**DC-10**

**SERVICE BULLETIN**

Bulletin 35-16  
DC-10 SC 1981/2134

OXYGEN - Passenger - Modify Oxygen Compartment In Passenger Seat Back And Compartment Partition.

**PASSENGER COMPARTMENT PARTITION OXYGEN COMPARTMENT - MODIFICATION**

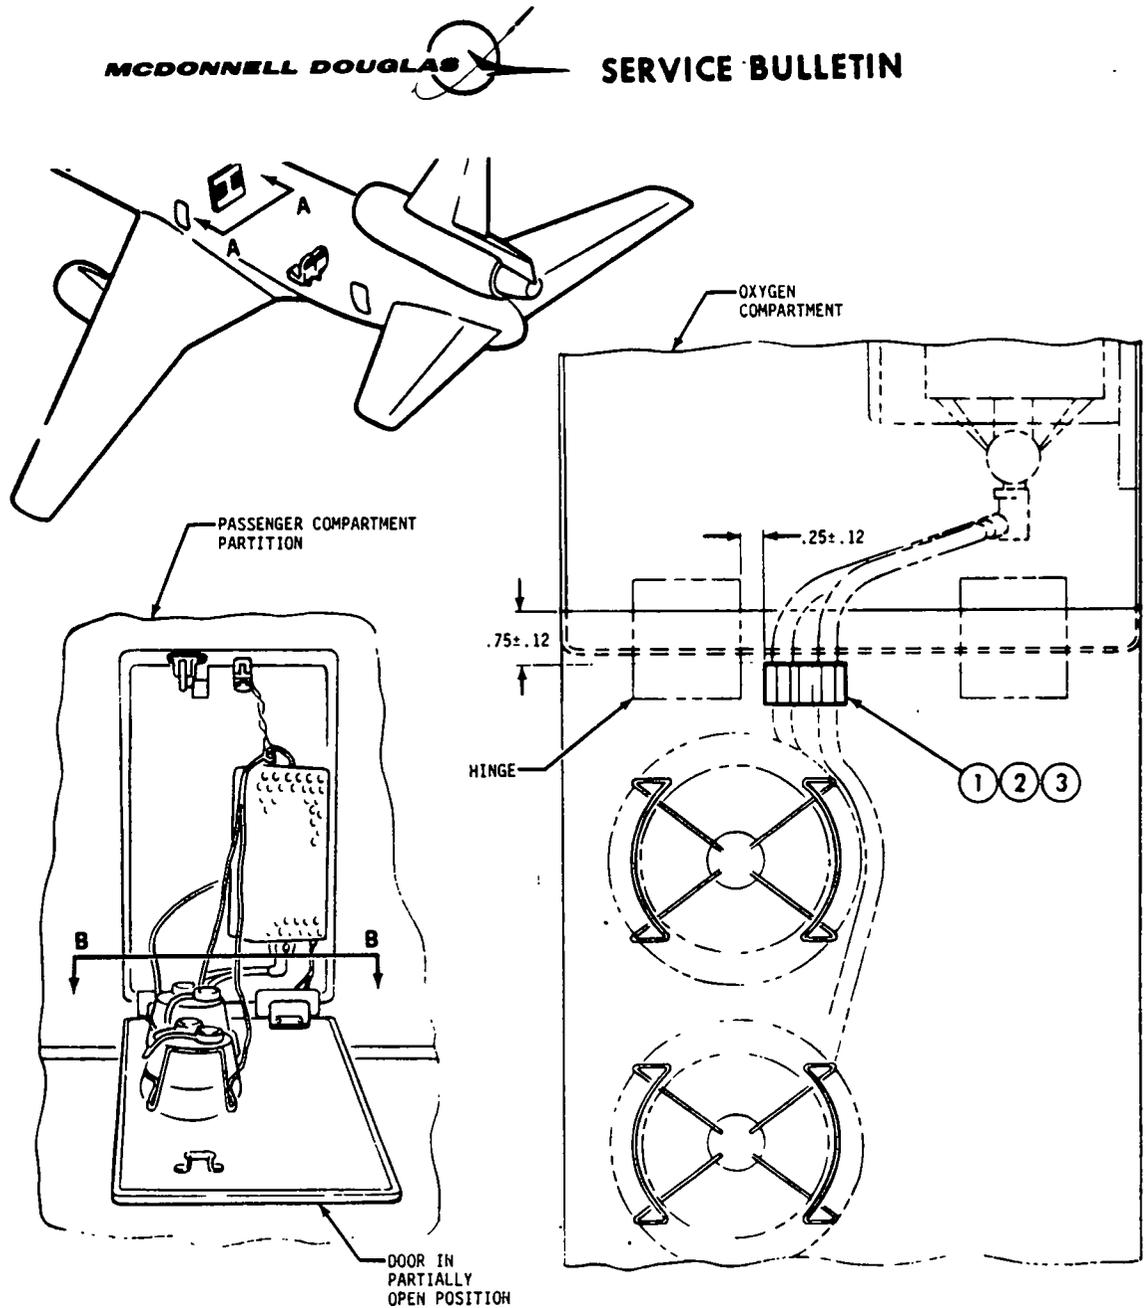
- ① BOND NMC700-3 TUBE RACK TO DOOR, TO DIMENSIONS SHOWN, USING EA9311 A/B ADHESIVE. (SEE DPS 1.07-66, TYPE 6.)

- ② REMOVE 4282 TAPE FROM NMC700-3 TUBE RACK AND OXYGEN COMPARTMENT DOOR.

- ③ BOND NMC700-3 TUBE RACK TO DOOR, TO DIMENSIONS SHOWN, USING EA9311 A/B ADHESIVE. (SEE DPS 1.07-66, TYPE 6.)
